Clinch River Nuclear Site  
NRC Docket No. 52-047

Subject: Submittal of Supplemental Information Associated with Hydrologic Engineering in Support of the Clinch River Nuclear Site Early Site Permit Application

Supplemental Information Regarding Site Safety Analysis Report Section 2.4,  
“Hydrologic Engineering”

Figure 2.4.3-22. Norris Reservoir Volume versus Elevation

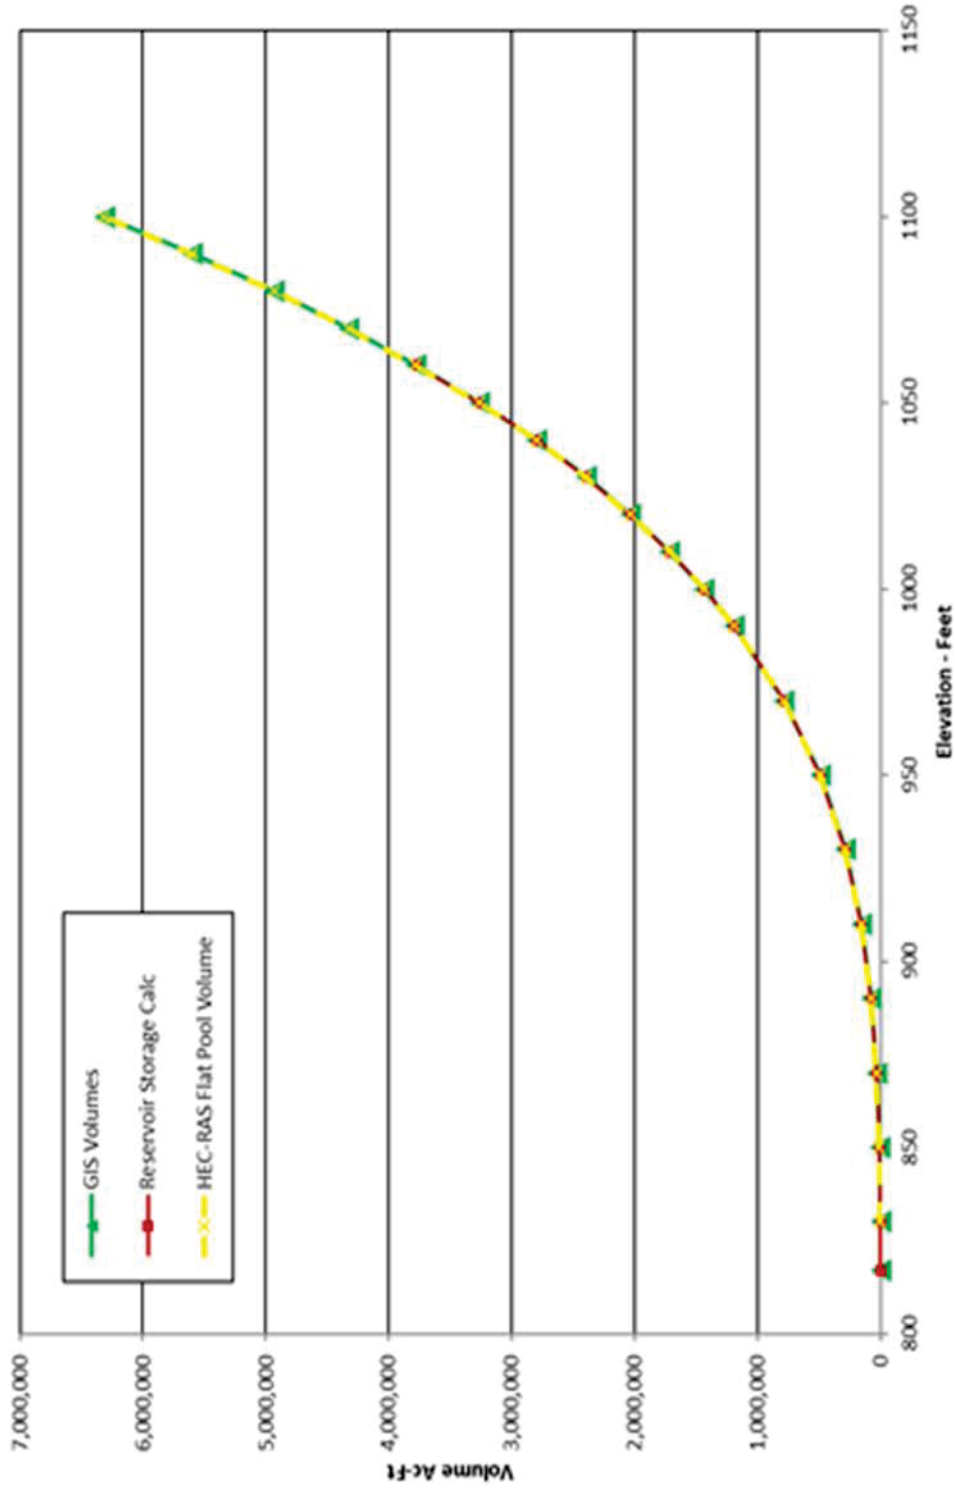
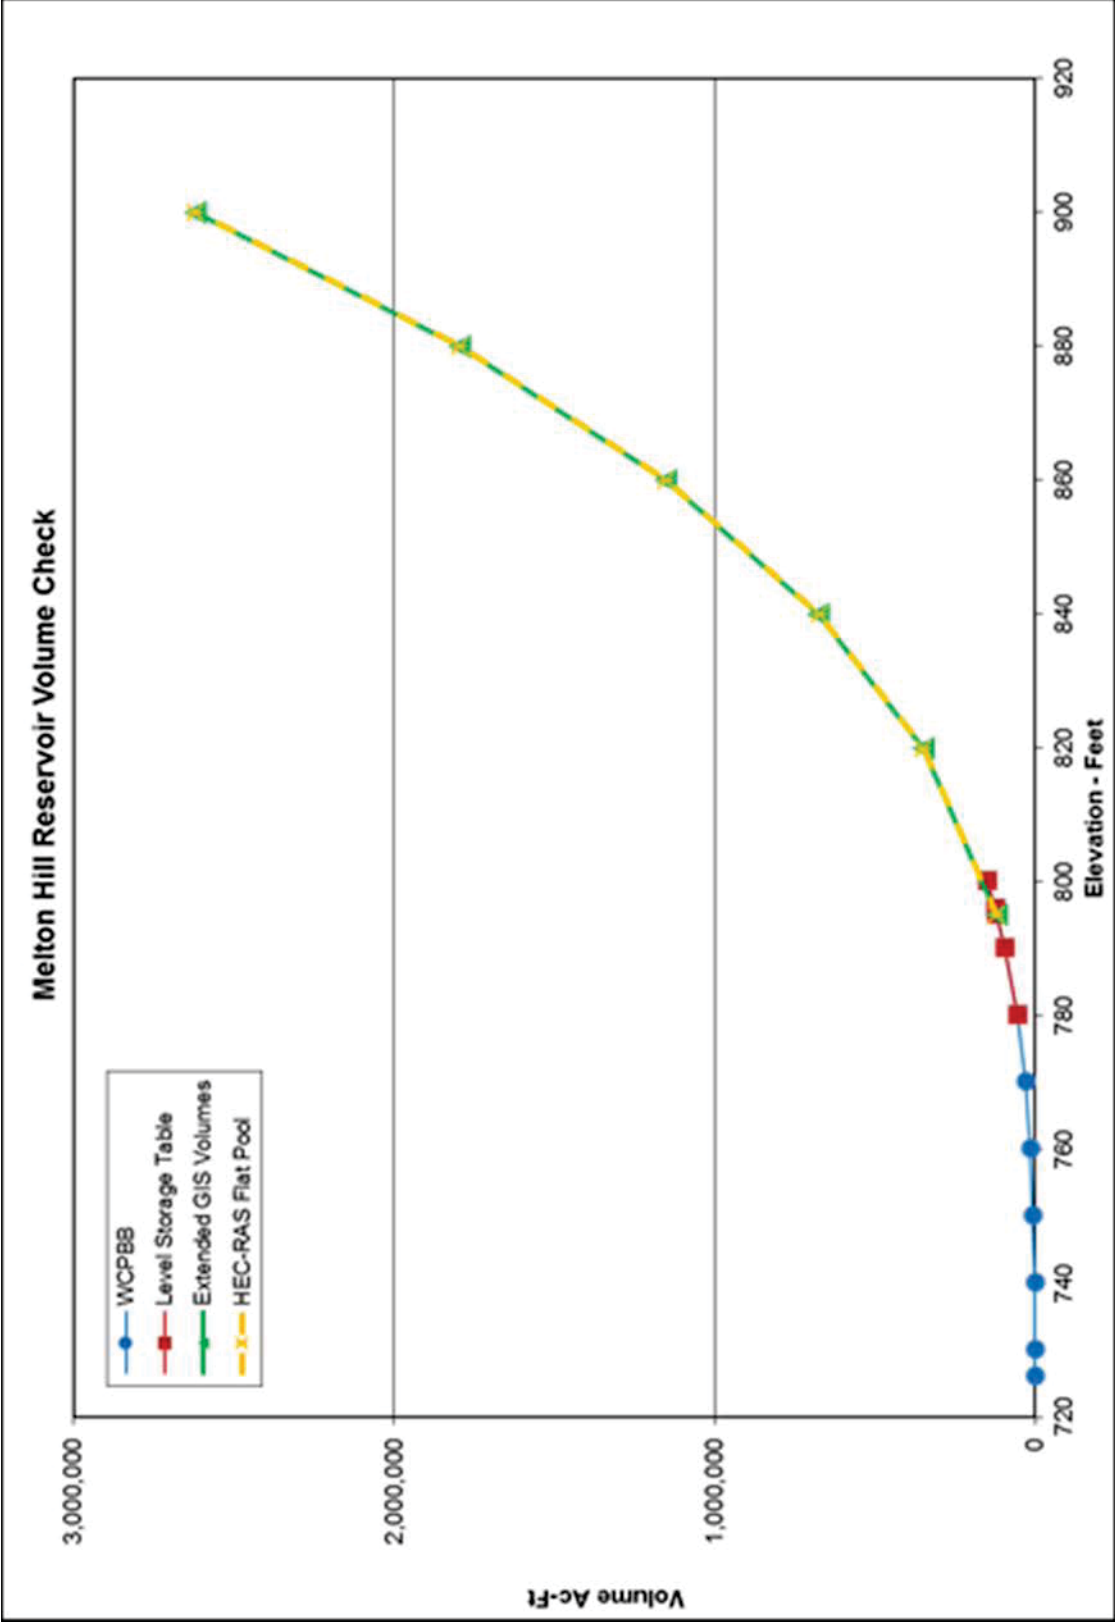
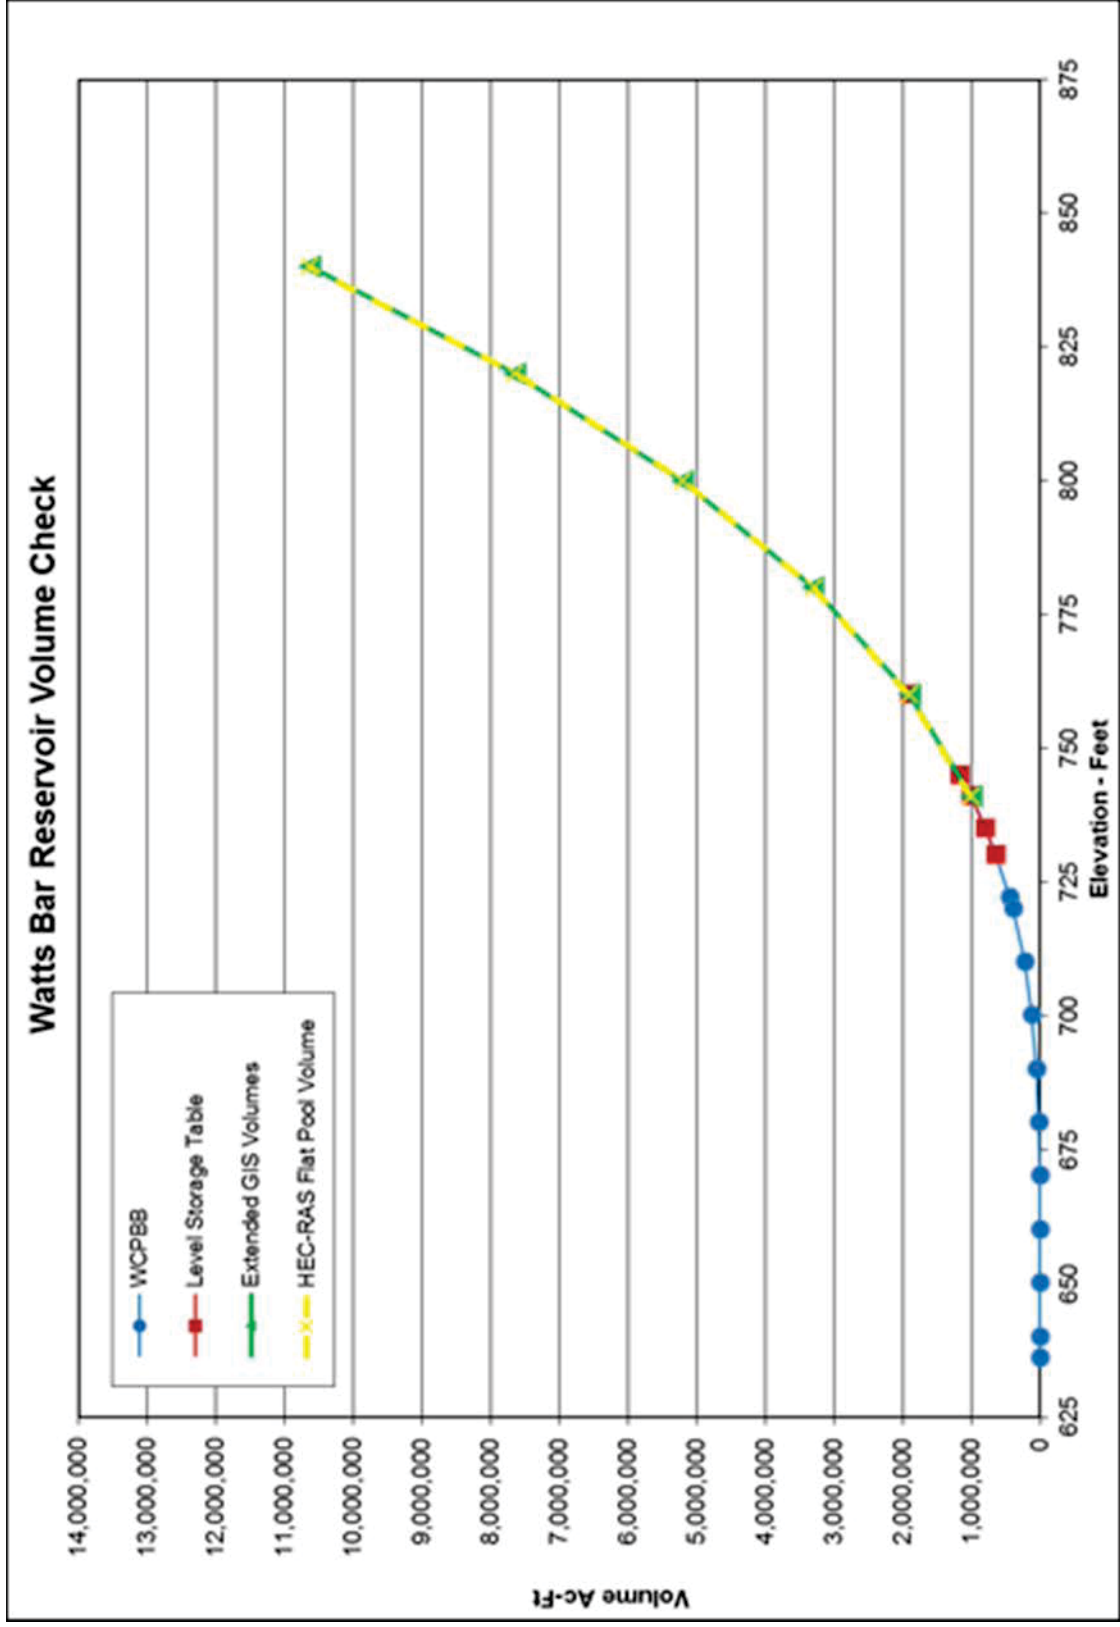
SSAR Subsection 2.4.3.4.3, "Stream Course Model Geometry Development and Calibration," and Subsection 2.4.3.4.4, "Design Storm Implementation," are being revised to add sufficient detail on the development of the HEC-RAS model, including a discussion of ineffective flow, impact of new fill on storage capacity, and new fill above PMF and away from the conveyance channel. In addition, figures depicting the reservoir storage curves and reference to the reservoir storage curves are being included in Subsection 2.4.3.4.3. See the markup provided in SSAR Subsections 2.4.3.4.3, first, second, fourth, and fifth paragraphs and 2.4.3.4.4, first and fifth paragraph, and new Figures 2.4.3-22, "Norris Reservoir Volume versus Elevation," 2.4.3-23, "Melton Hill Reservoir Volume versus Elevation," and 2.4.3-24, "Watts Bar Reservoir Volume versus Elevation," in Attachment 3.

A discussion describing the methods and results of the reservoir volume verification and figures showing the methods and results are being added to SSAR Subsection 2.4.3.4.3, "Stream Course Model Geometry Development and Calibration." See the markup provided in SSAR Subsection 2.4.3.4.3, first paragraph, third and fourth sentences and reference to Figures 2.4.4-1, Sheets 1 - 12, in first sentence in Attachment 3.

Figure 2.4.4-5. Seismic Inflow Hydrographs for 500-Yr June Flood Event – Norris Dam

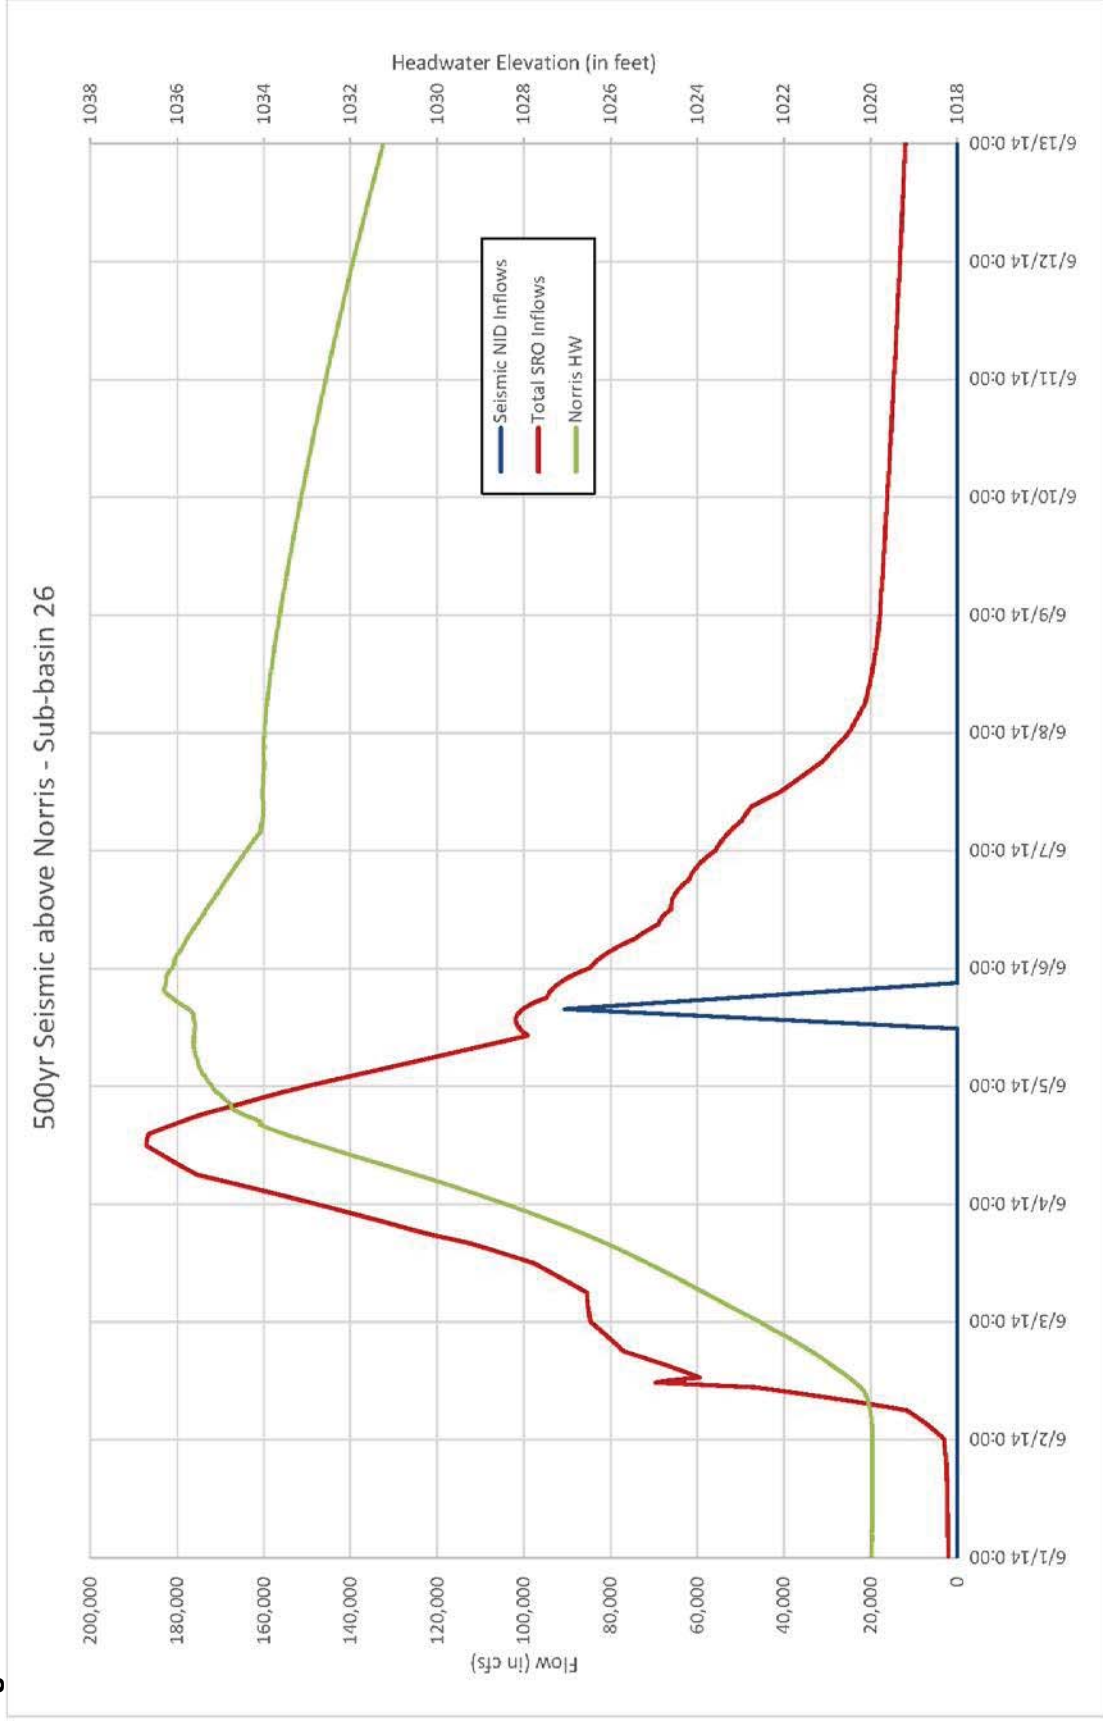
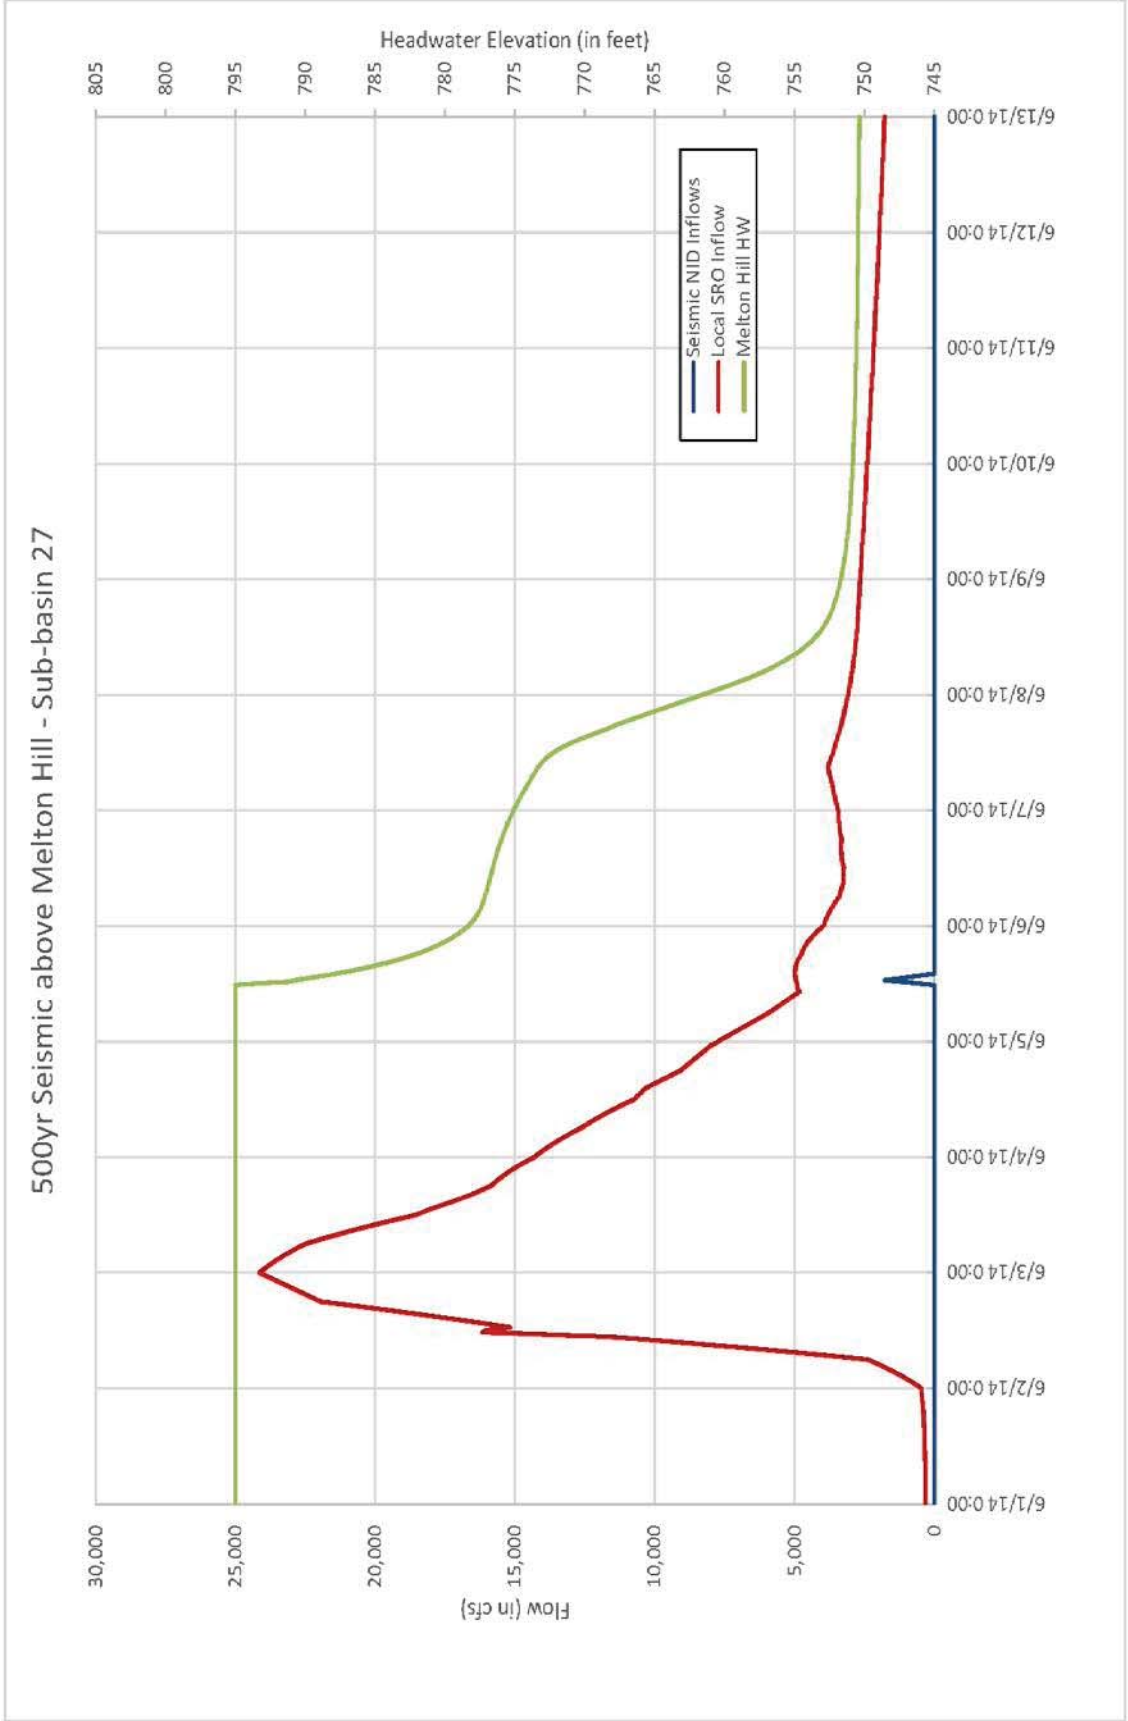
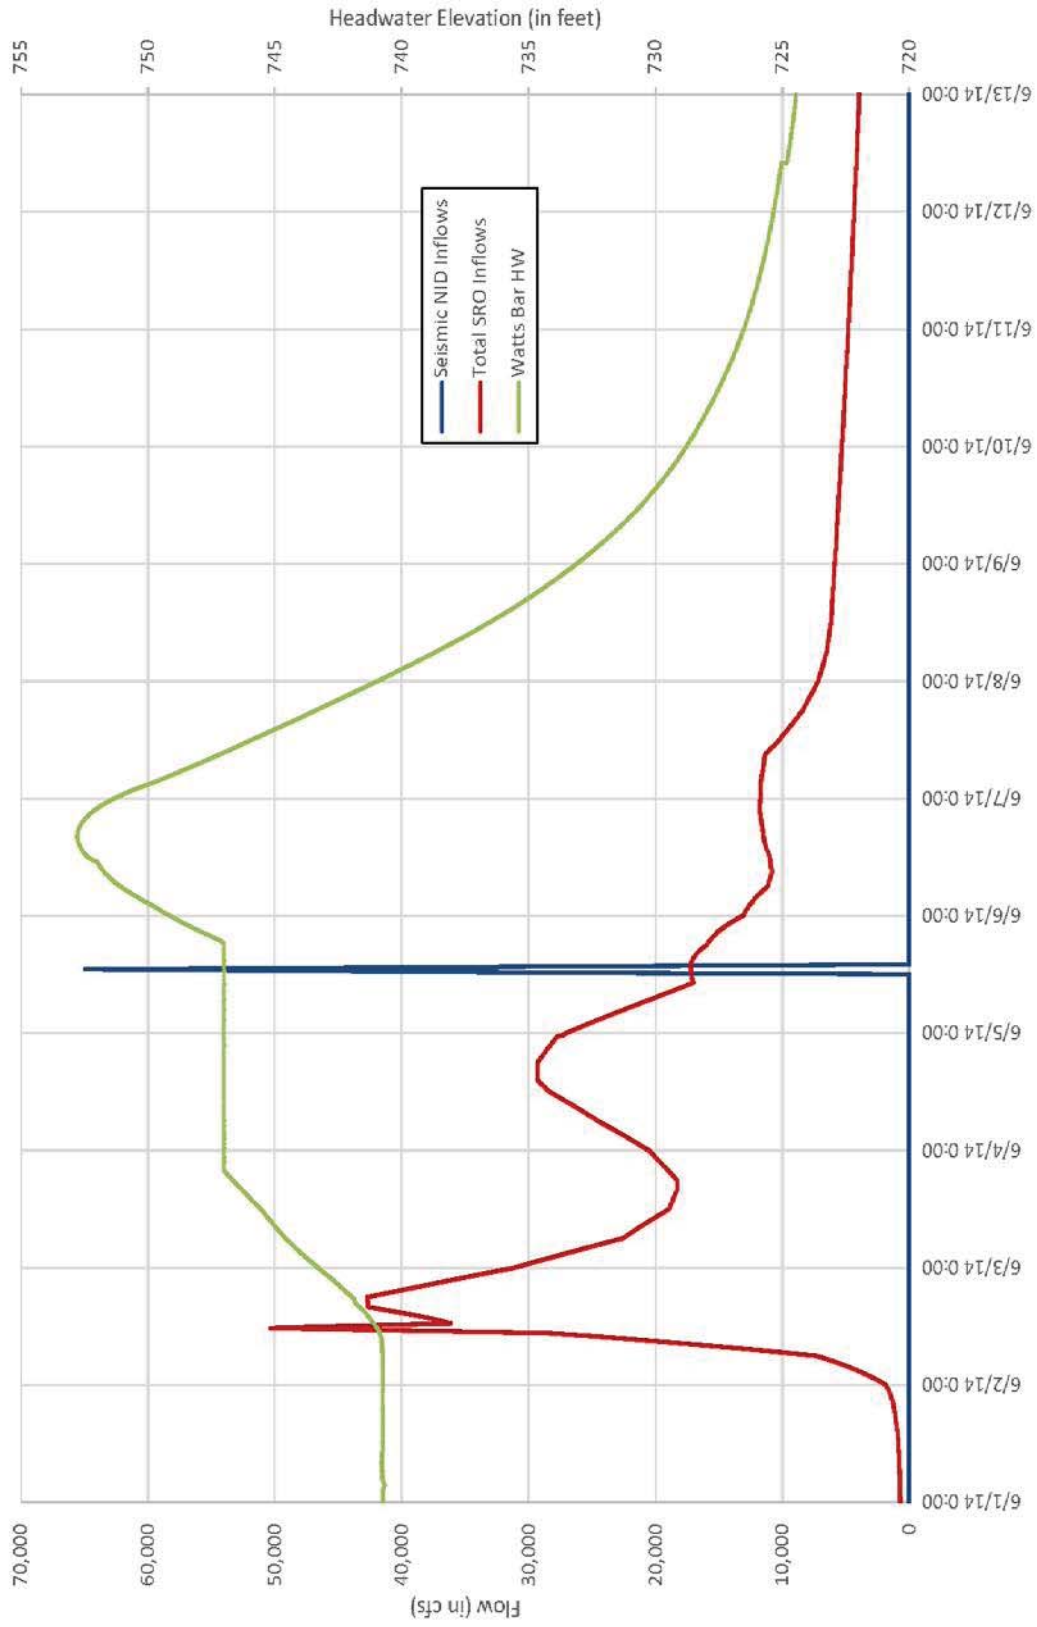
The seismic NID inflow hydrographs, Figure 2.4.4-5, "Seismic Inflow Hydrographs for 500-Yr June Flood Event - Norris Dam," Figure 2.4.4-6, "Seismic Inflow Hydrographs for 500-Yr June Flood Event - Melton Hill Dam," and Figure 2.4.4-7, "Seismic Inflow Hydrographs for 500-Yr June Flood Event - Watts Bar Dam," are being added to SSAR 2.4.4. Reference to the Figures is being added to SSAR Subsection 2.4.4.2.1, "Seismic Failure Analysis," at the end of the sixth paragraph under the subheading "Flood Routing." See the markup in SSAR Subsections 2.4.4 and the new Figures 2.4.4-5, 2.4.4-6, and 2.4.4-7, in Attachment 4.

Figures 2.4.4-5 to 2.4.4-7 are added
